# DeKalb County Historic Preservation Commission

## Staff Report

- L. 1201 Springdale Road, Warner McConaughey. Demolish greenhouses, construct a new garage, modify driveway, install wooden fencing, and construct a back deck. **1246967**

# EDUPUGANTI RESIDENCE

PROPOSED DETACHED GARAGE

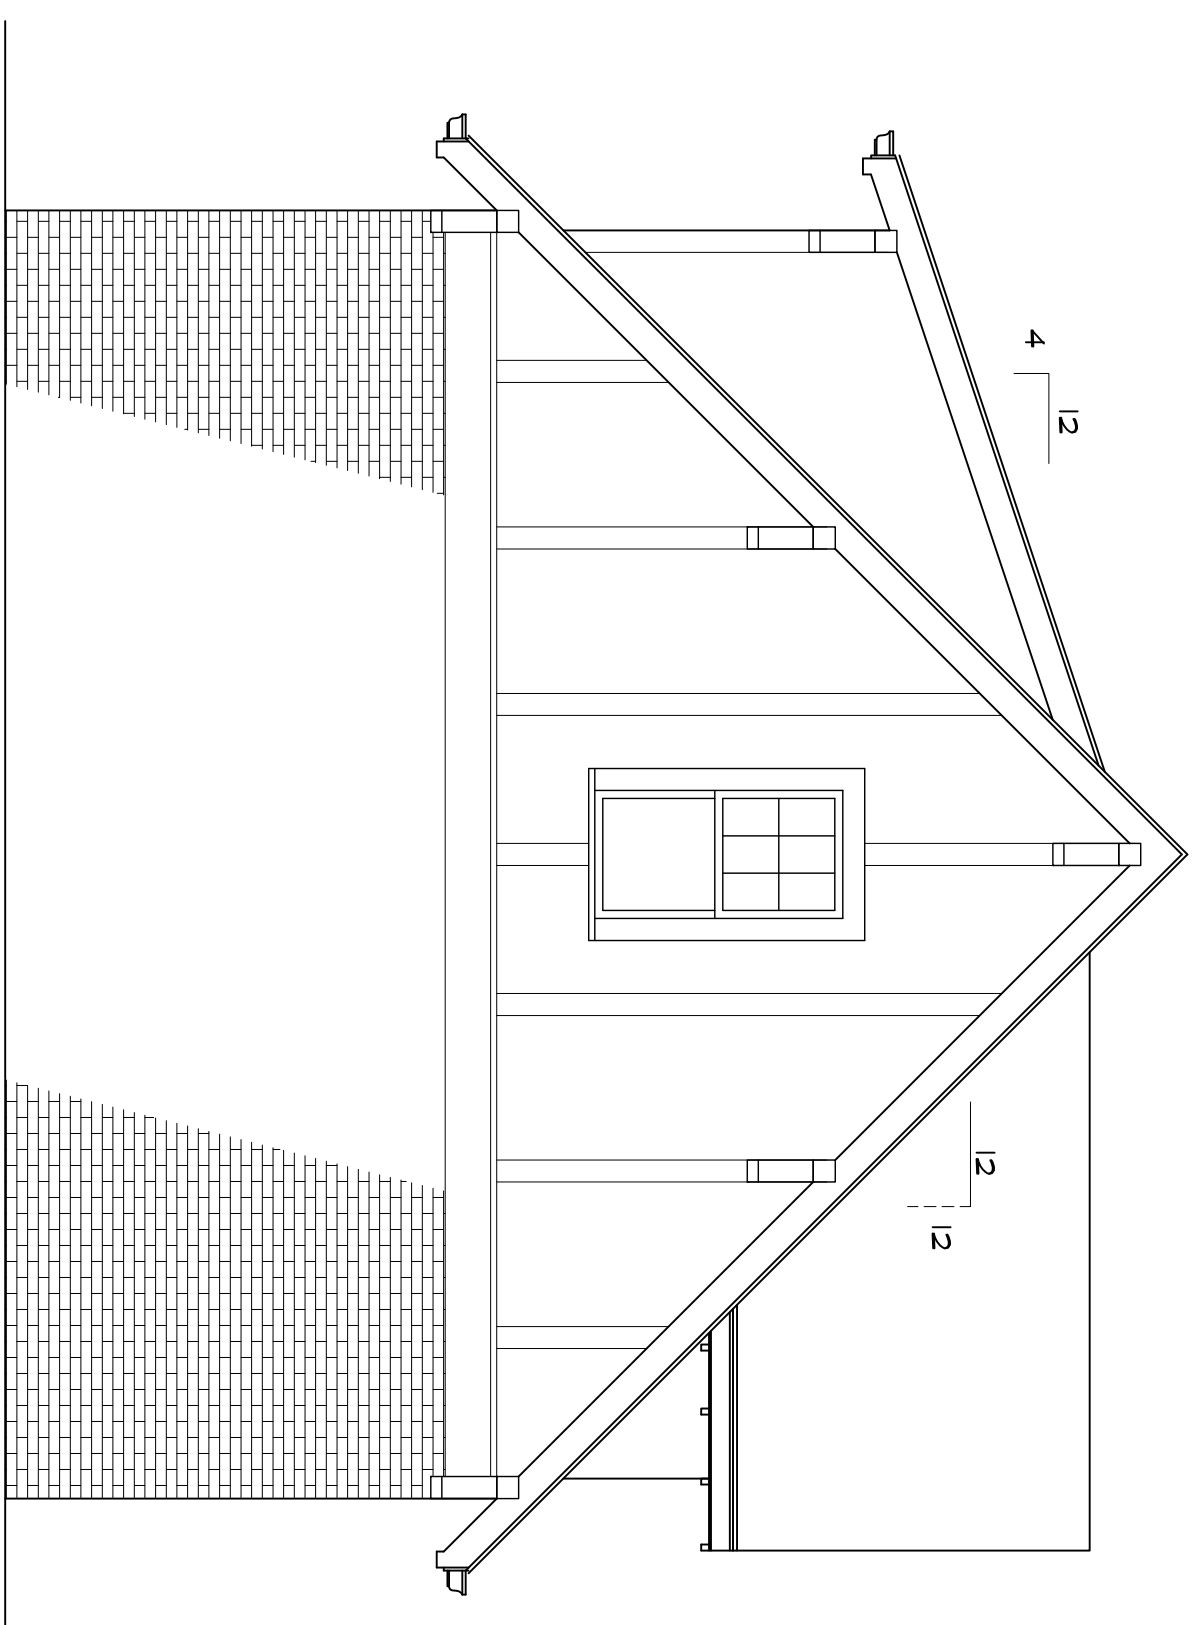
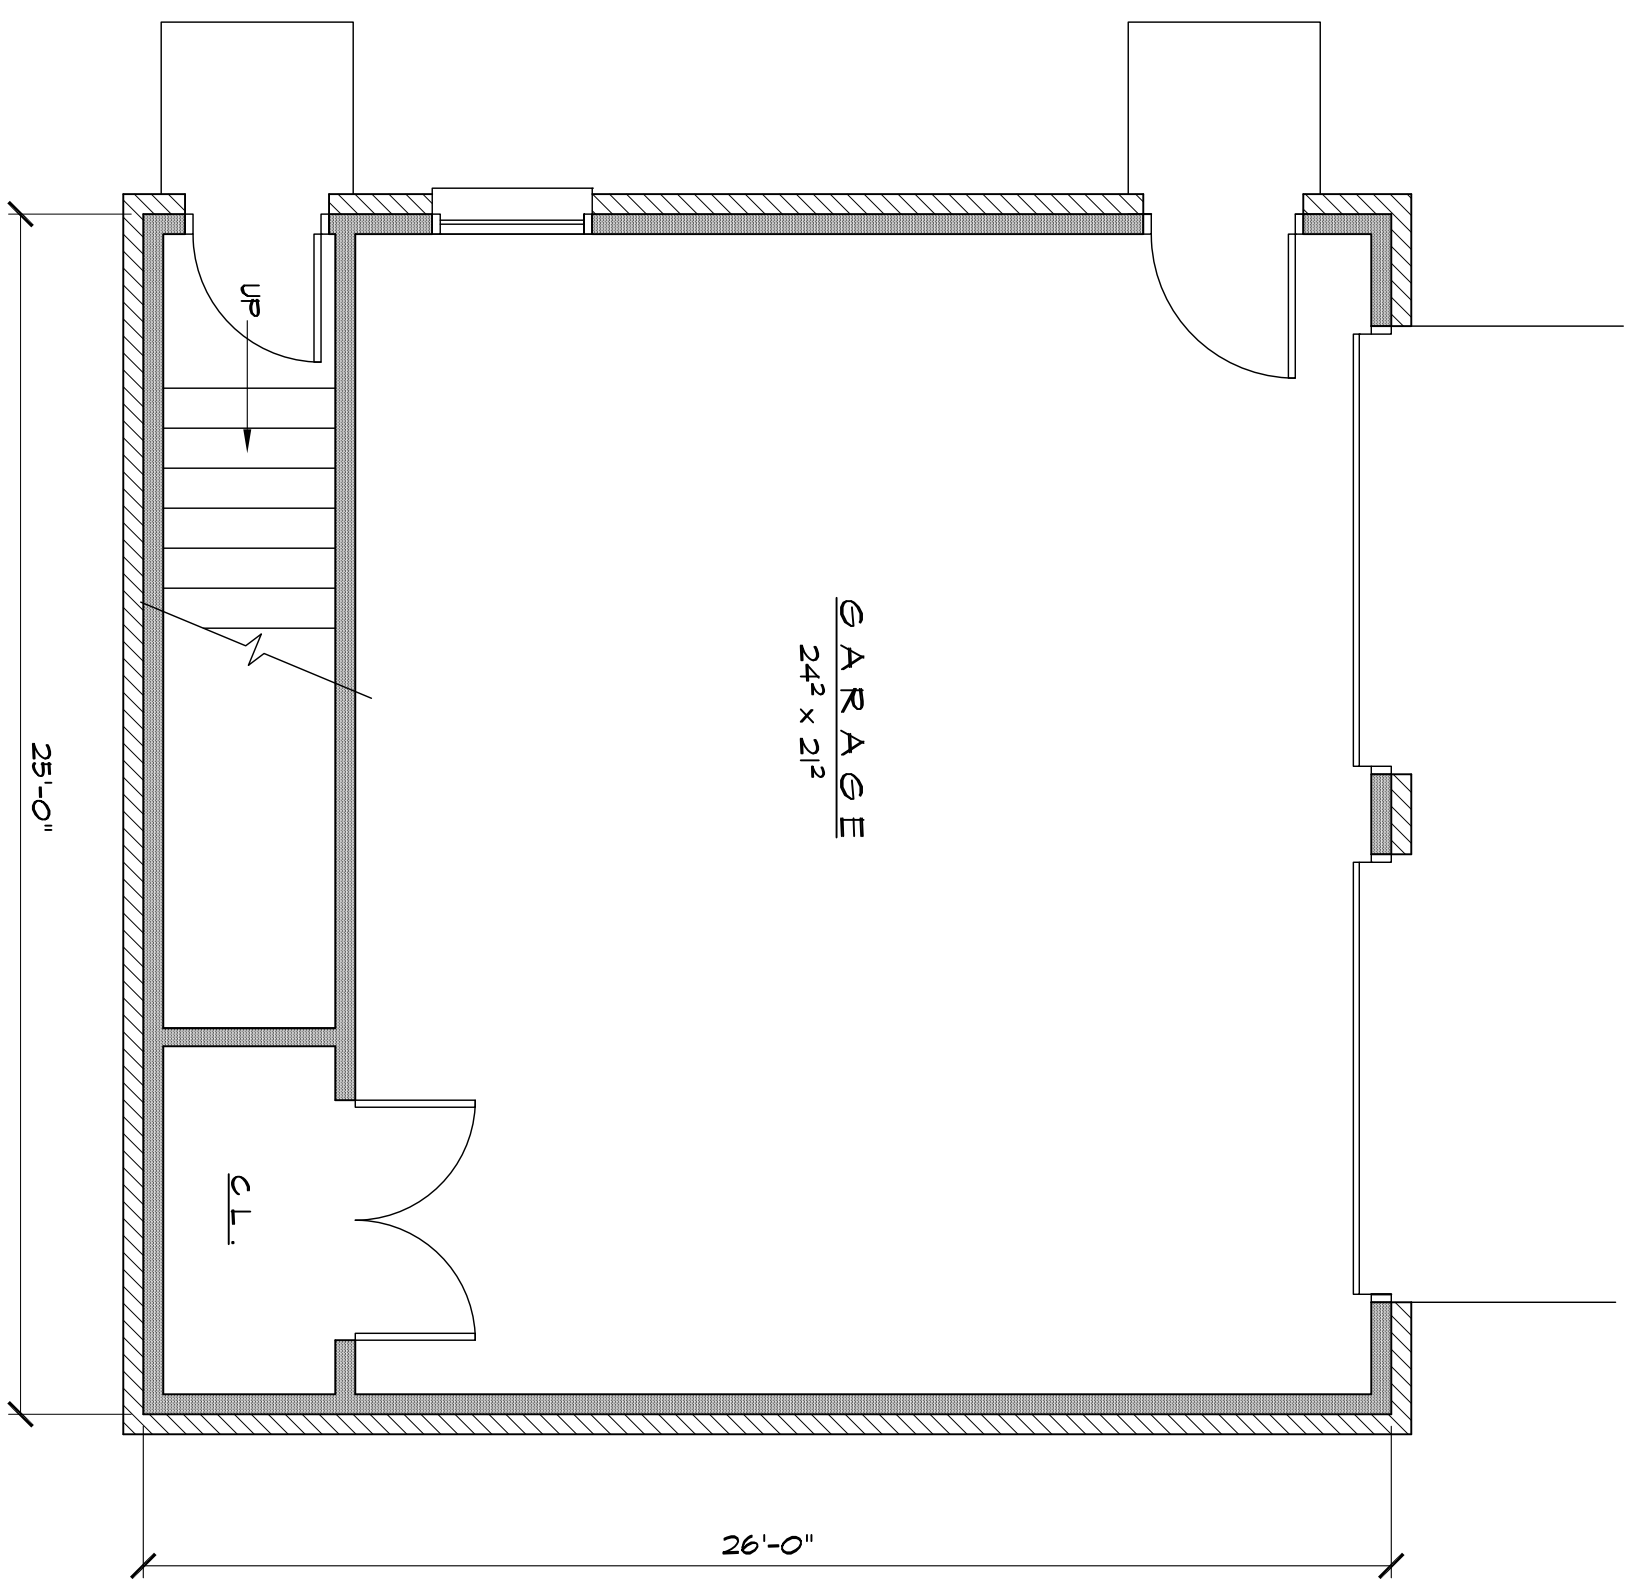
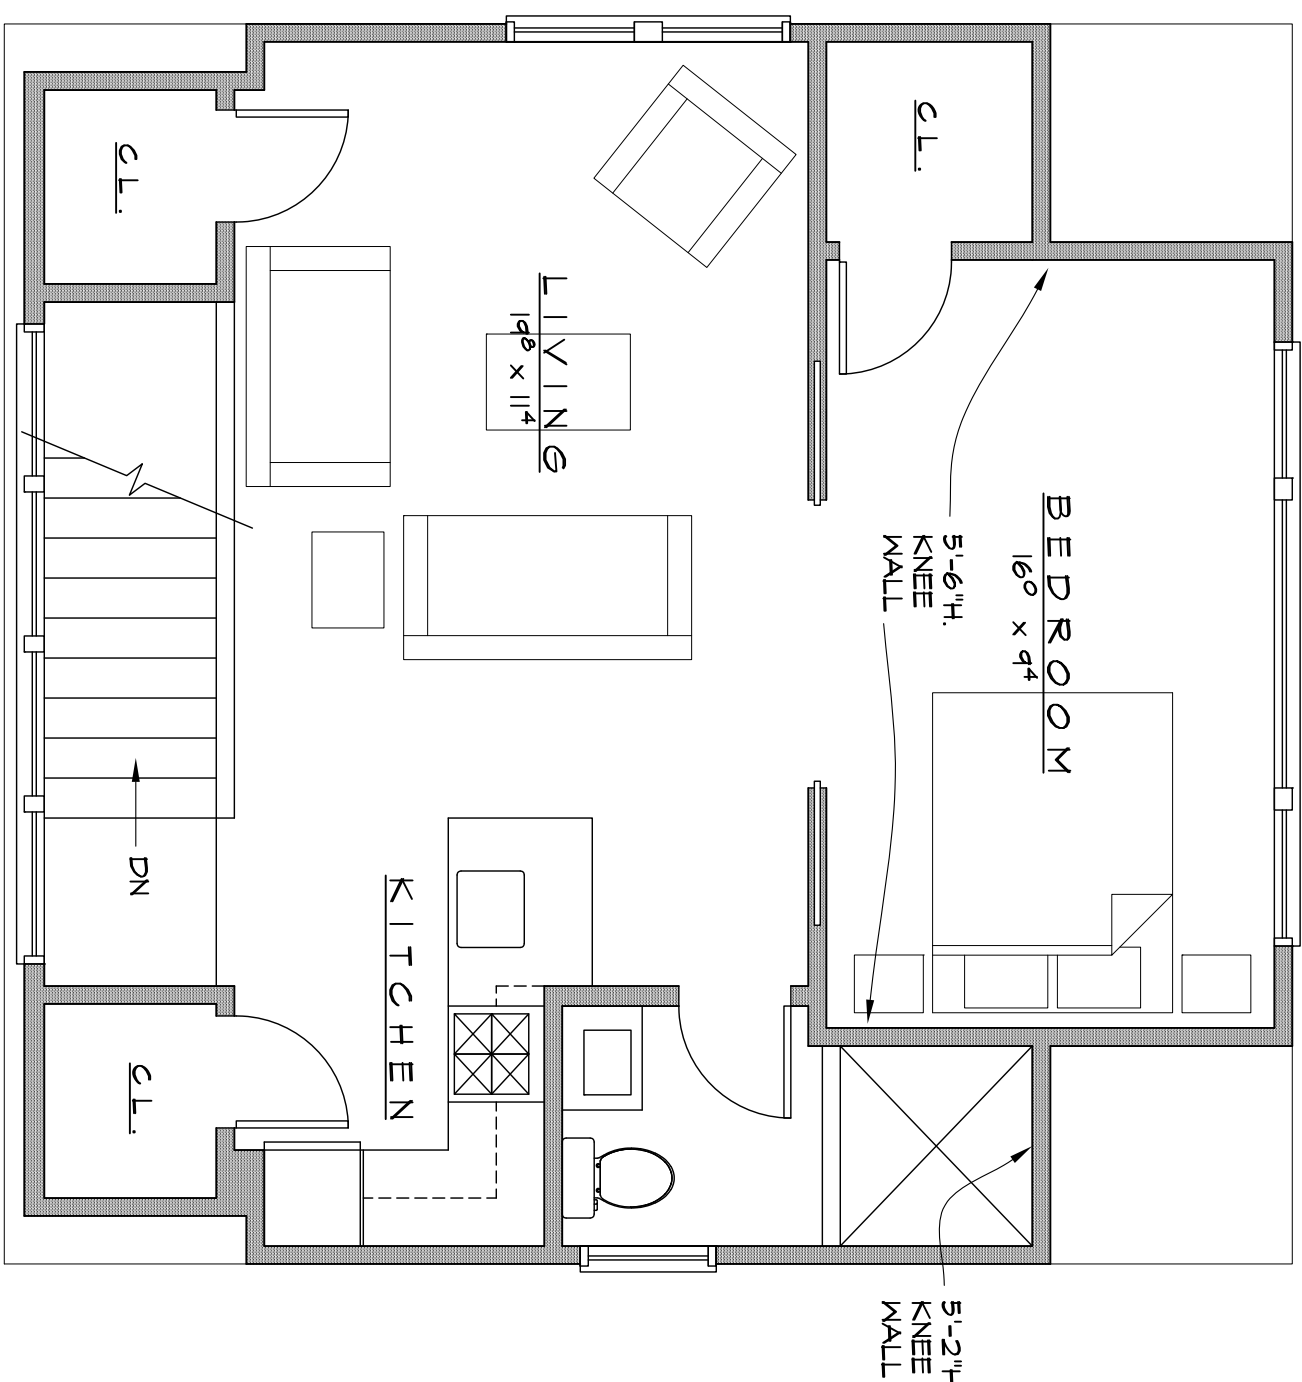
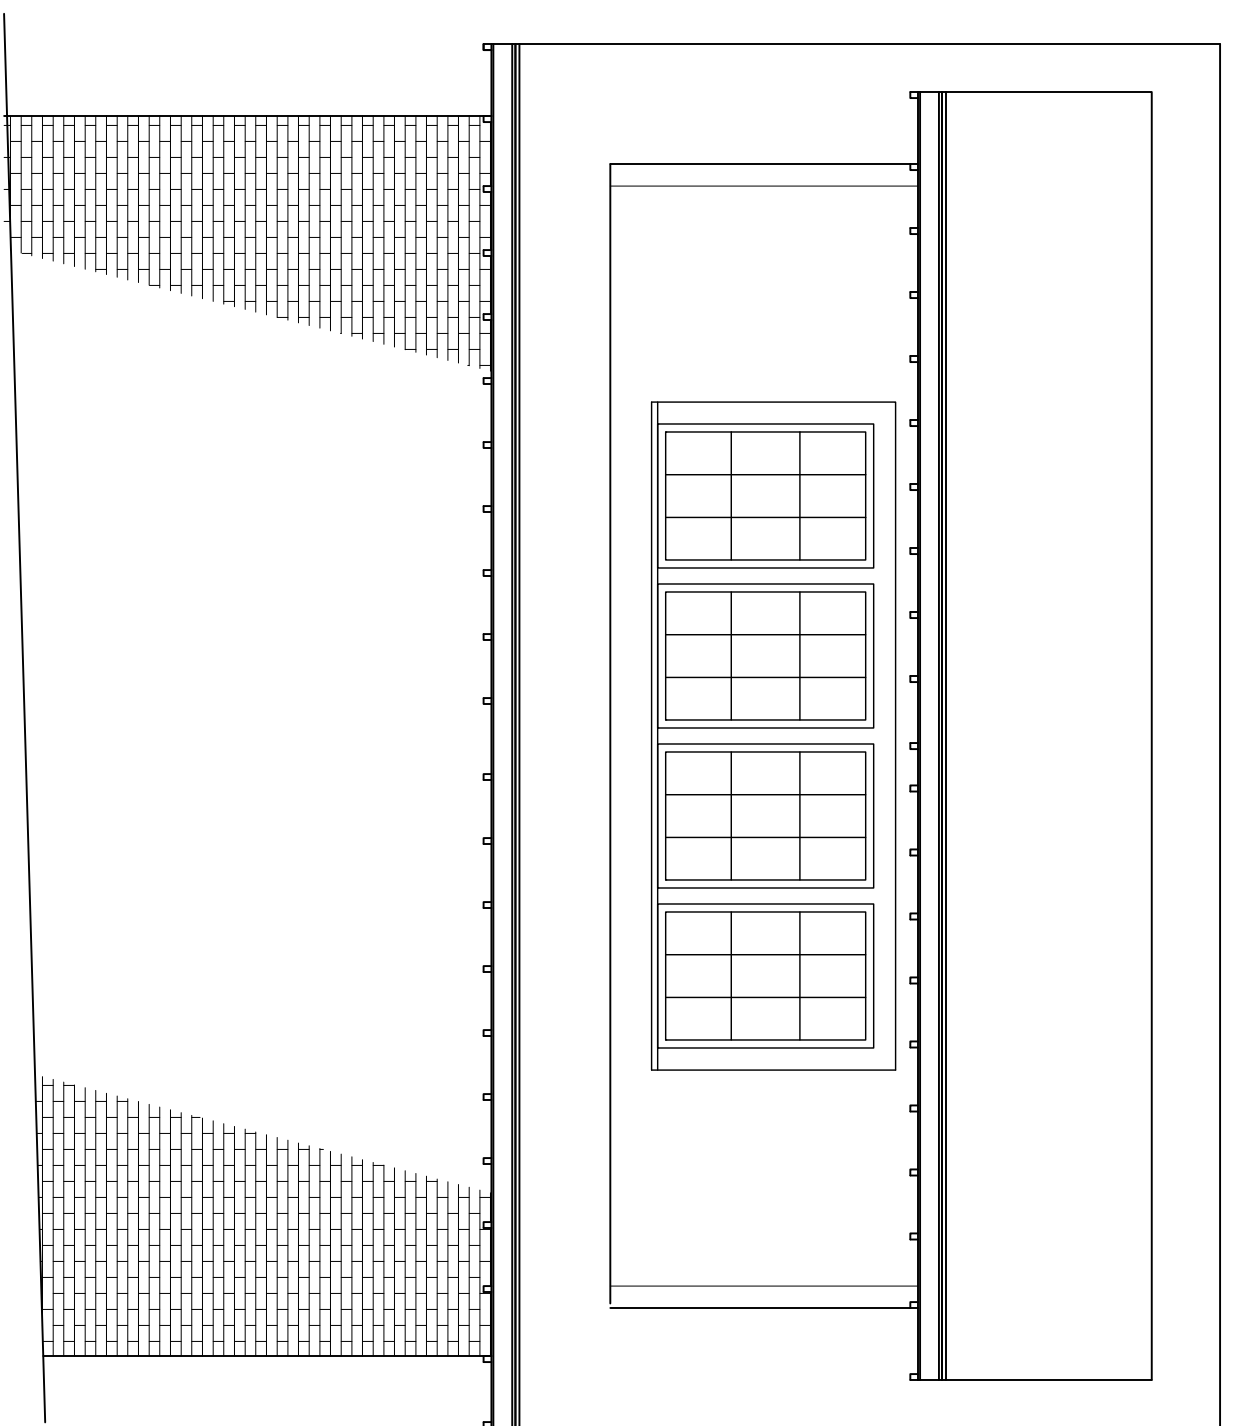
tomorrow morning. A quick final question before we finalize the report: What is the height of the home? And can you confirm that there will be no exterior changes to the main property, only interior renovations?

The existing house seems to be about 26' tall, as measured from the finished first floor of the house.

The proposed garage slab would be about 5' below the finished floor of the house. So from the finished grade across the front of the house, the house is about 29 feet tall. The garage would appear to be 19 feet tall.
